**CIVIL AVIATION
AUTHORITY**

ENGINEERING DEPARTMENT

AIRWORTHINESS DIRECTIVES

FUEL PRESSURE LINE MODIFICATION — DRAWING N° FM 07 —

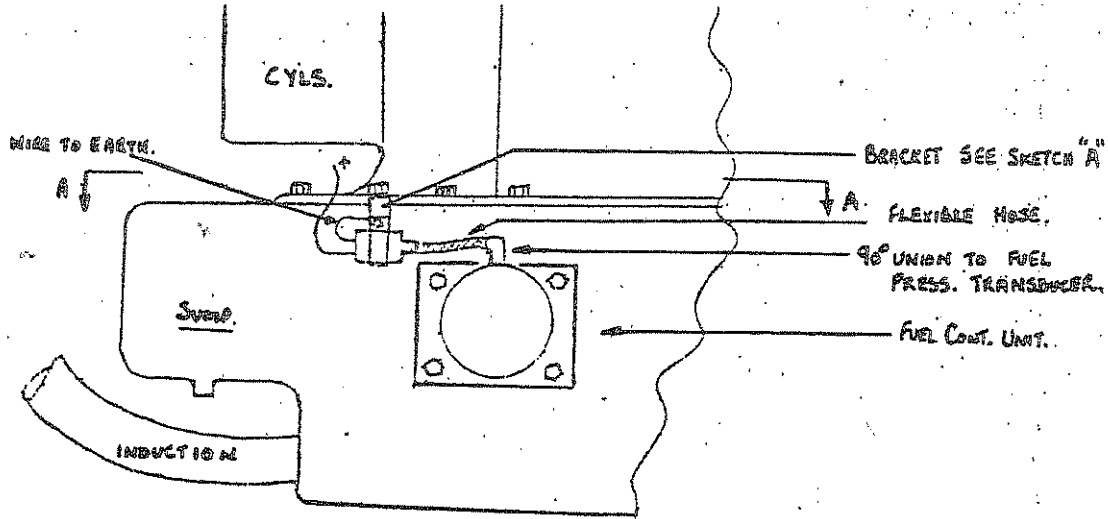
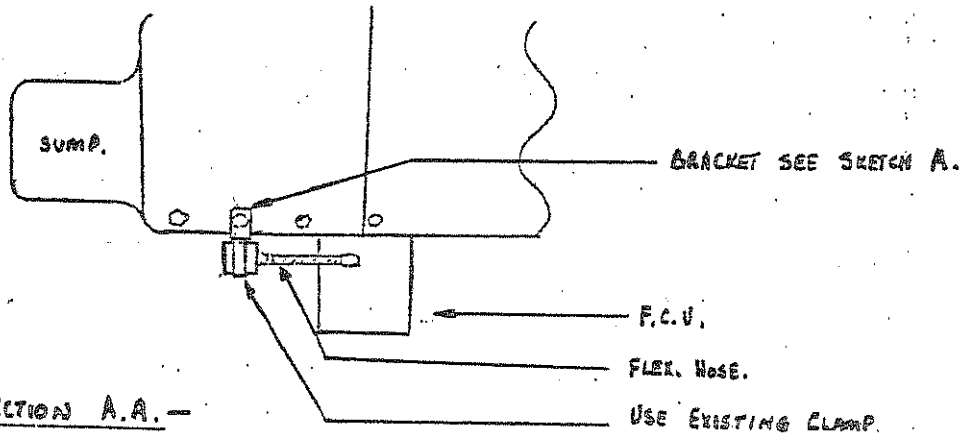
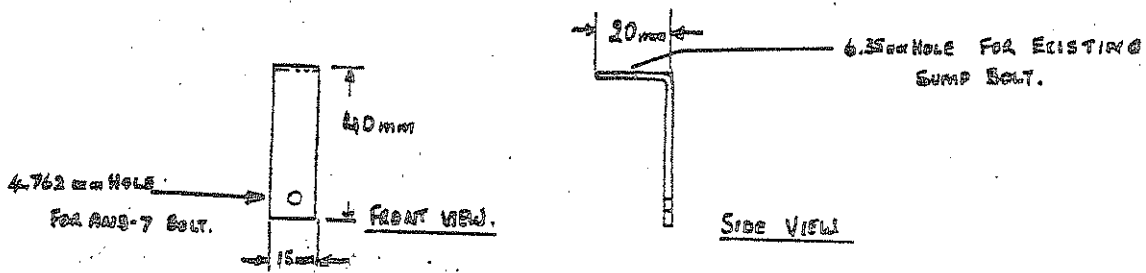
The flexible fuel pressure hose between the fuel control unit and fuel pressure transducer can become hard and brittle causing eventual fuel leakage due to its close proximity to the exhaust segments. To prevent this accomplish the following:

- (ii) Remove fuel pressure transducer from existing location (clamped to no. 3 cylinder induction pipe) and retain clamp and attaching hardware.
 - (iii) Manufacture bracket from 4130 steel to dimensions shown on sketch A, minimum thickness of 0,060 and fit bracket to new position below no 1 cylinder utilizing existing sump attach bolt as indicated in sketch.

- (iv) Attach fuel pressure transducer to steel bracket with existing fuel pressure transducer clamp using AN 3-7A bolt, AN 960-10 washer and AN 363-1032 nut.

- (v) Manufacture new flexible hose, total length 11 cm, measured from outside ends of hose fitting nuts.
 - (vi) Original hose may be utilized and shortened, provided the hose is serviceable, by removing hose end fitting, which attaches to fuel pressure transducer, shortening hose to correct length and re-fitting hose end fitting.

MATERIALS: 4130 STEEL
1.524 mm
THICKNESS.

Wiring Diagram Example:

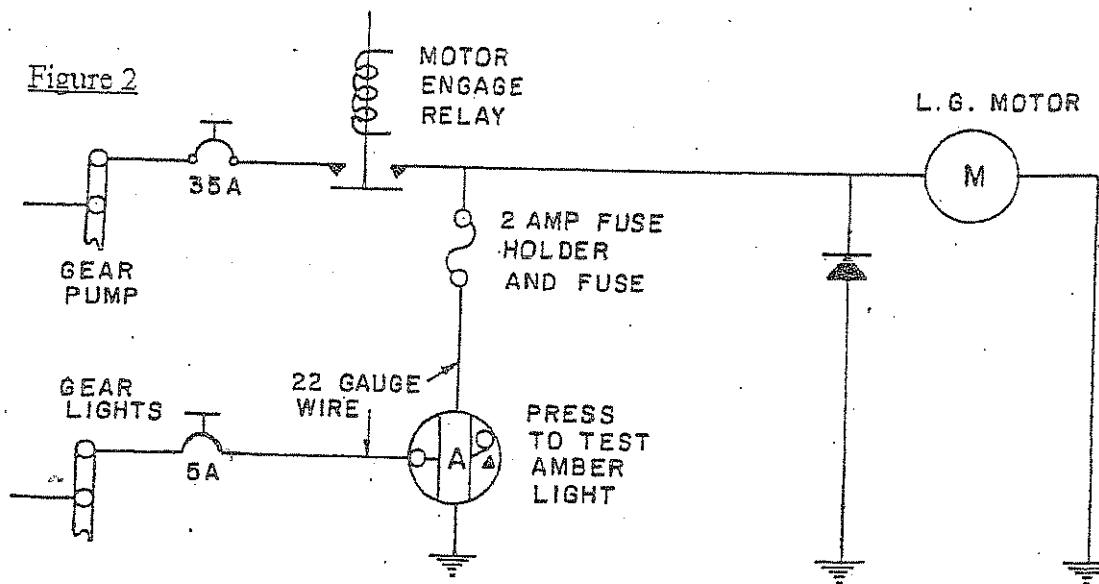
A hydraulic pump motor "ON" annunciator lamp must be installed to alert the pilot when the condition described above exists. (Landing gear in transit light).

1. Install an amber warning light on the instrument panel in the cockpit where it is easily visible to the pilot.
2. Wire the warning light mentioned in 1 above into the aircraft wiring between the relay and the landing gear drive motor as indicated in Figure 2 below and install a 2 amp fuse holder and a fuse close to the pick-off point to protect the wiring.
3. Placard the newly fitted amber light with placard wording as indicated by Figure 1.
